Re: Water Treatment Plant – Construction Contingency Expense No. 4

Proposal No. 017 (RFP 012): Filter Slab Modifications:

Request For Proposal No. 012

Re: Filter Slab Modifications

6 DETAIL
NO SCALE

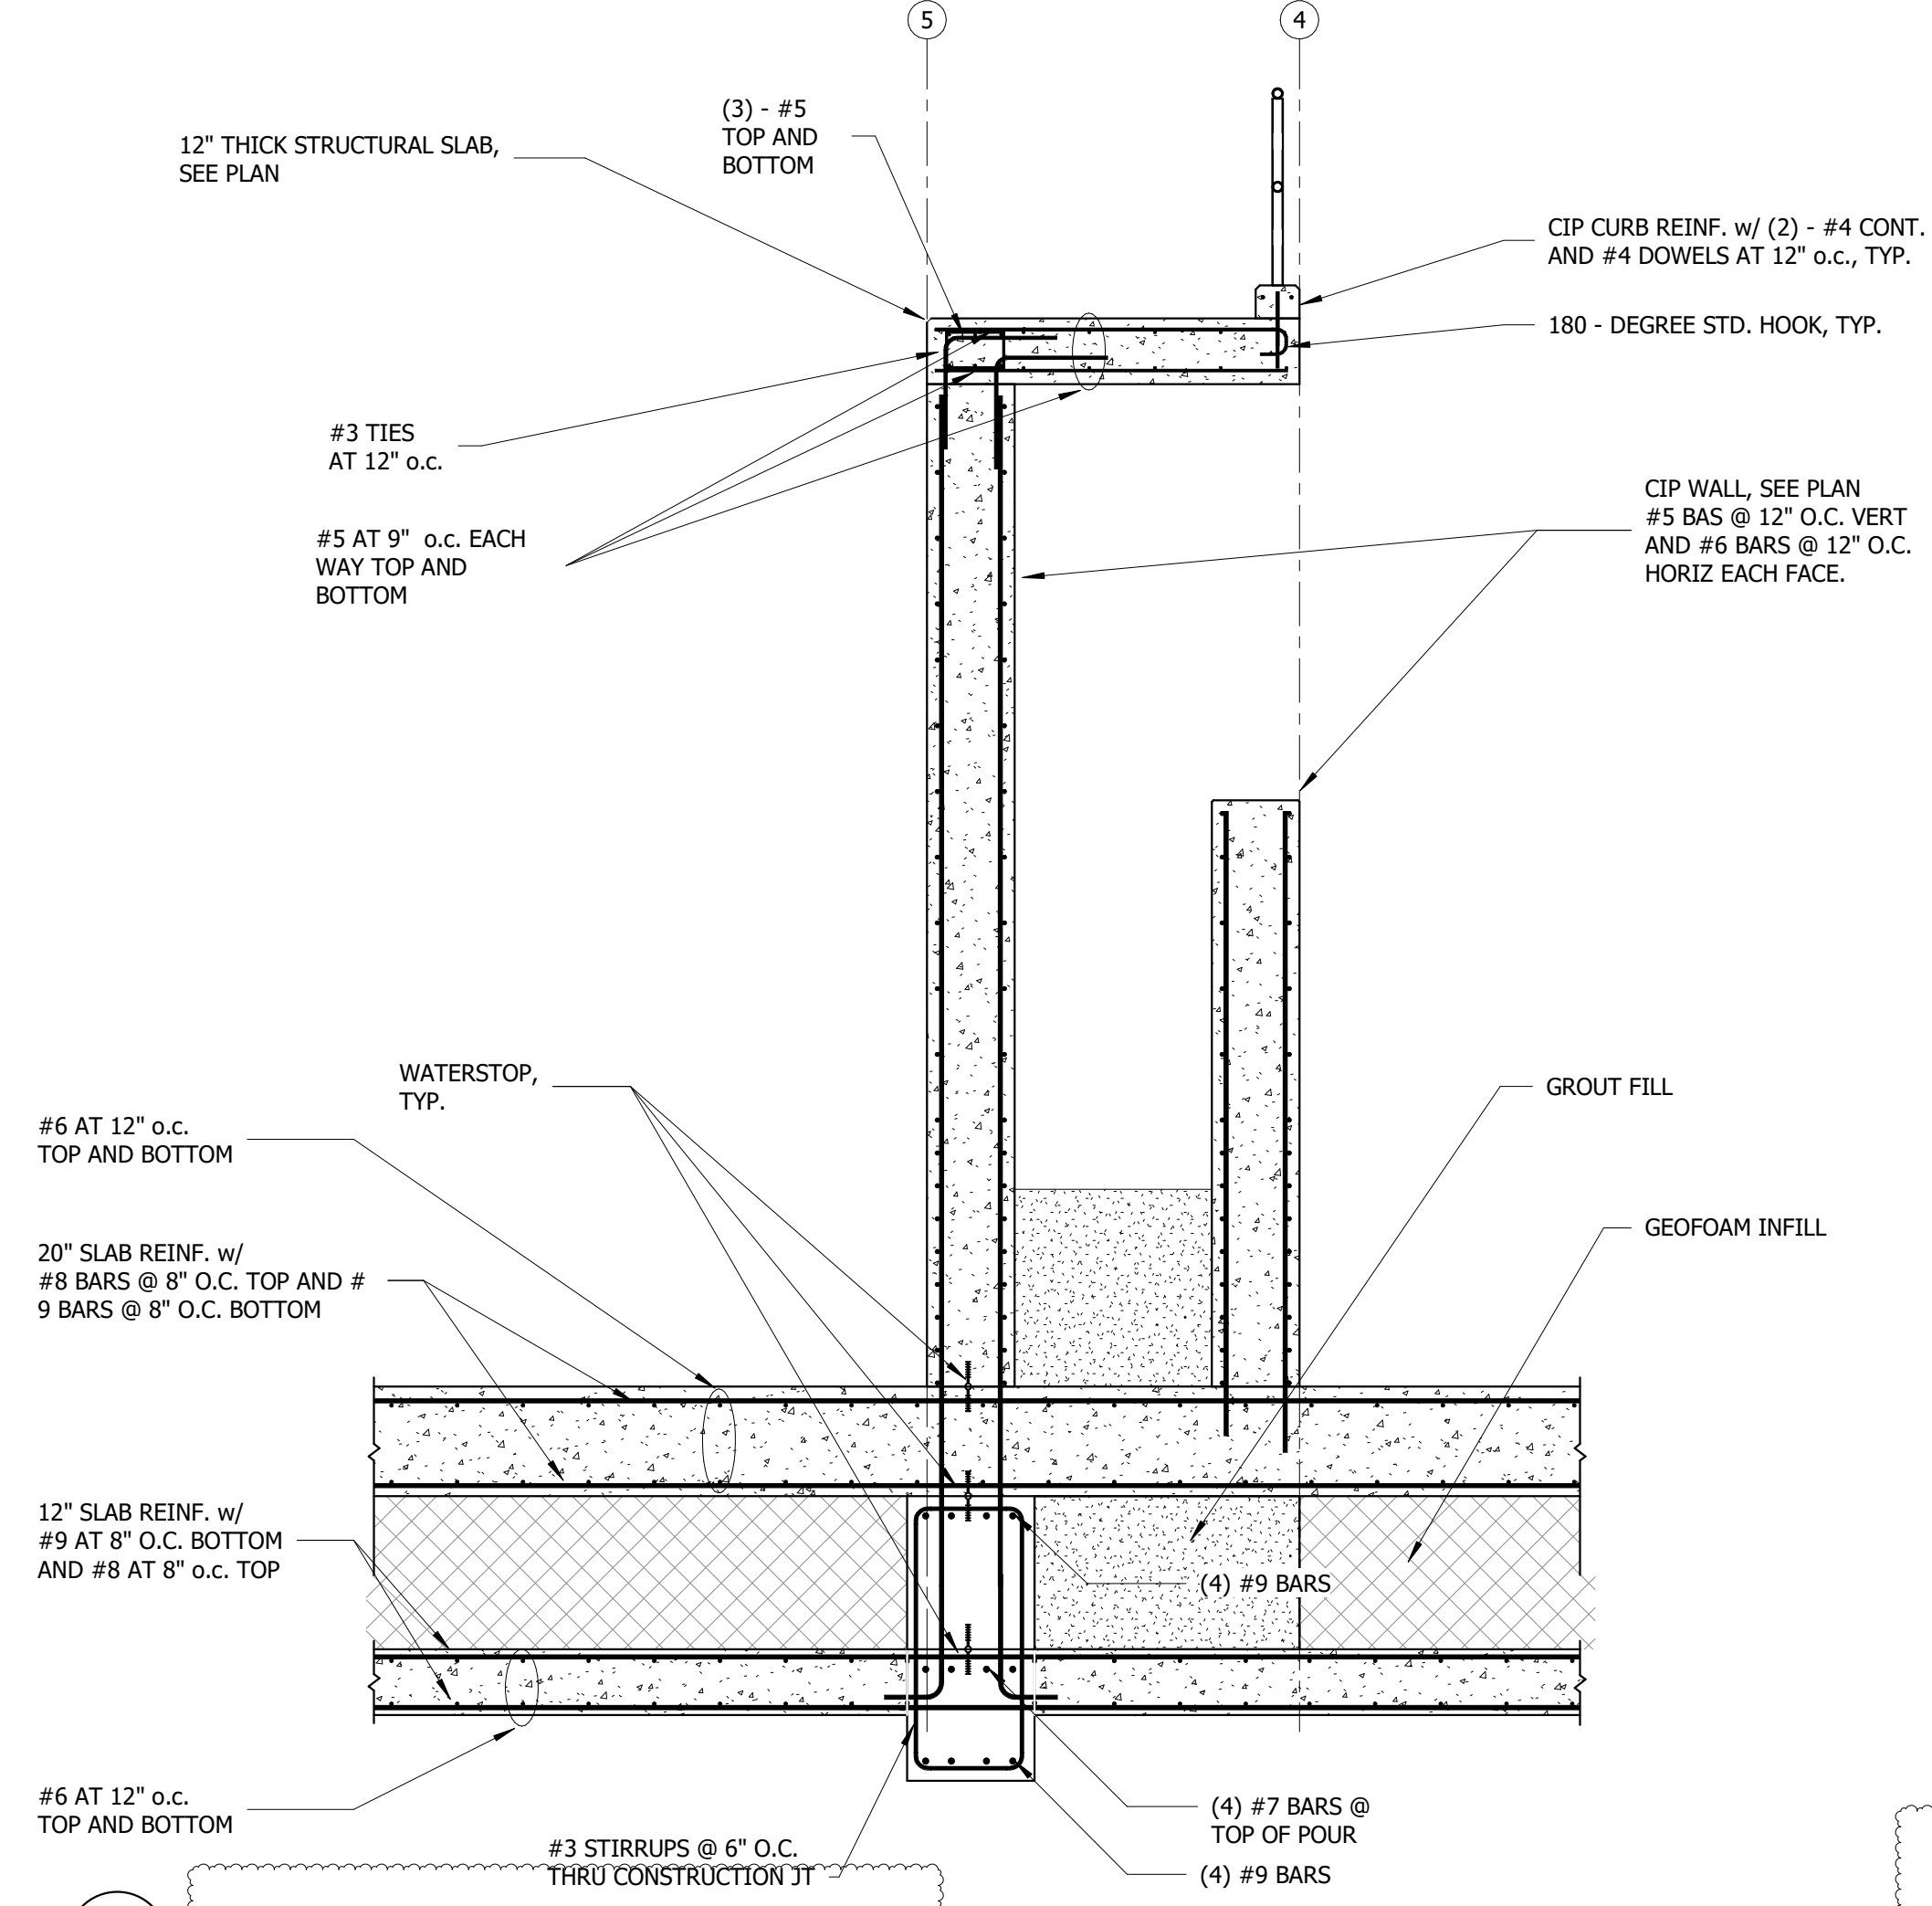
AE2S requests pricing from Magney for changes to the filter slab and CIP supports beams in the clearwell and backwash reclaim tank. Changes include but are not limited to extending the filter slab at elevation 113', increasing the slab thickness to 20" and increasing the CIP beams in the clearwell and backwash tank from 24" to 52". We also request pricing for raising the height of the gullet wall and filter trough to 121'-11". See attached drawings for any additional changes required. Once approved, Contractor will need to resubmit submittal 135 – Concrete reinforcement WTP structural slab, based on provided drawings. See sheets S203, S301, S302, S303, S305, S504, S505 and S601 attached.

Ryan,
Magney Construction, Inc. is pleased to present the following quotation to furnish the necessary labor, material, and equipment to complete the requested changes in RFP 012 - Filter Slab Modifications. To extend and thicken the slab at 113' with required rebar modifications, increase the Clearwell and Backwash beam heights to 52". Along with raising the gullet walls to 121'11". The costs associated with change are summarized below.
